Design Review Subcommittee (DRSC)

SUBJECT: **Minor Cultural Heritage Permit (MCHP) 22-111, Koch-Wong Residence**, a request to add a new garage and remodel the interior of an existing two-story, two-unit multi-family dwelling for the property located at 238 West Mariposa in the Residential Medium Density (RM) zoning district.

Exhibit 3: Existing Garage Location

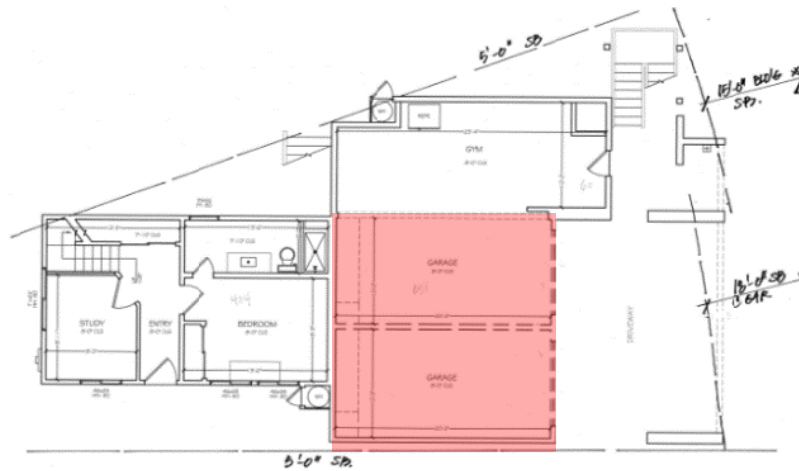
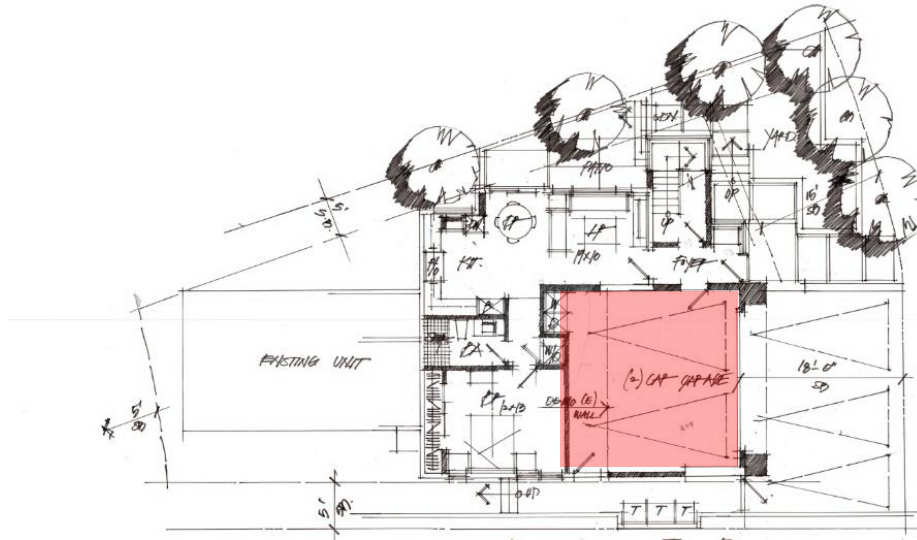
Exhibits 3 and 4 show the wall within the existing two-car garage being demolished to accommodate a new two-car garage.
